UNITED STATES  
DEPARTMENT OF THE INTERIOR  
BUREAU OF LAND MANAGEMENT

Salado 29 26 33 Fed Com -2H (API# 30-025-42637)

# Delaware Basin Changes to APD for Federal Well

**Well Name:** Salado Draw 29-26-33 Fed Com #2H

**Salado Draw 29-2H**  
**Drilling Program "Quick-Look"**

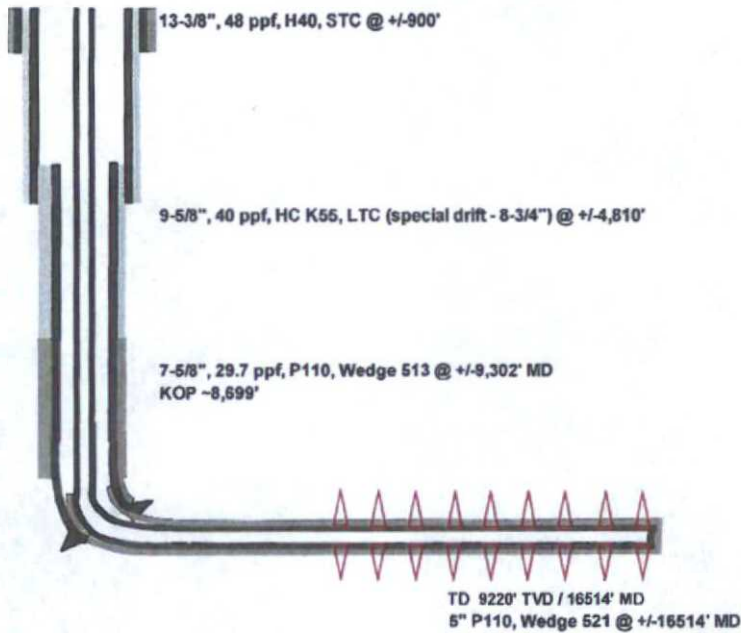
### Changes to APD for contingency string:

#### Lead 1 Slurry:

Density: 11.5 ppg  
Yield: 2.66ft<sup>3</sup>/sk  
Sacks: 193 sks  
Water: 15.563 gal/sk  
Excess: 20%  
Coverage: 4,500' – 8,500'

#### Lead 2 Slurry:

Density: 12.5 ppg  
Yield: 1.60ft<sup>3</sup>/sk  
Sacks: 86 sks  
Water: 8.614 gal/sk  
Excess: 20%  
Coverage: 8,500' – 9,303'

# Salado Draw 29-2H Drilling Program "Quick-Look"

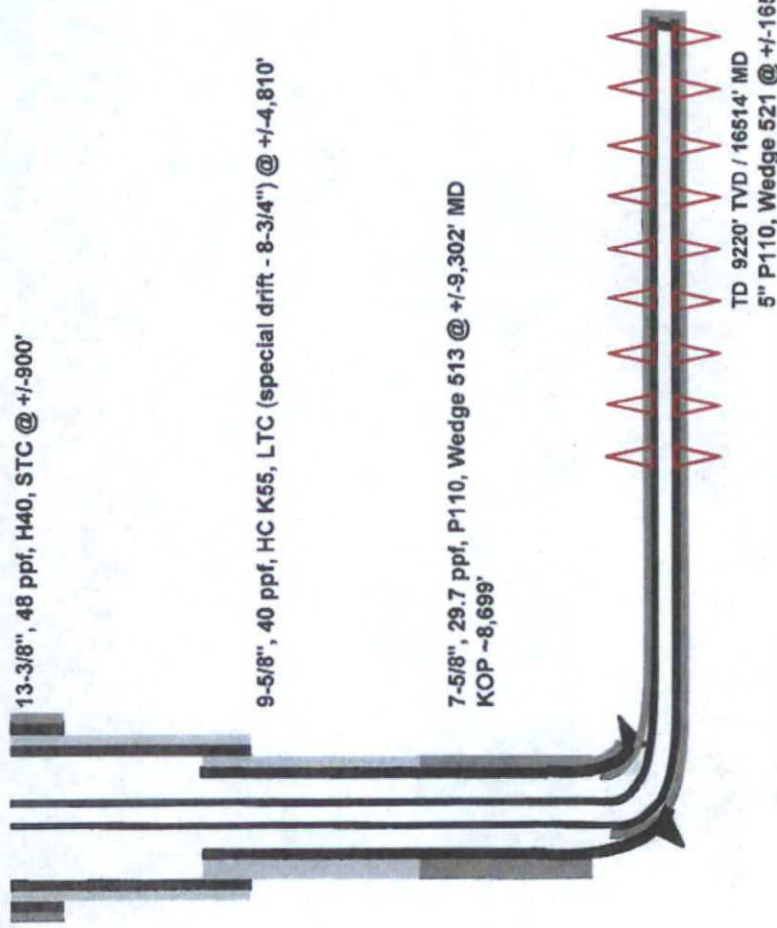
Original plan was to drill a three hole section wellbore, and will not be changed to a 4 hole section string.

**Changes to APD for production string:**
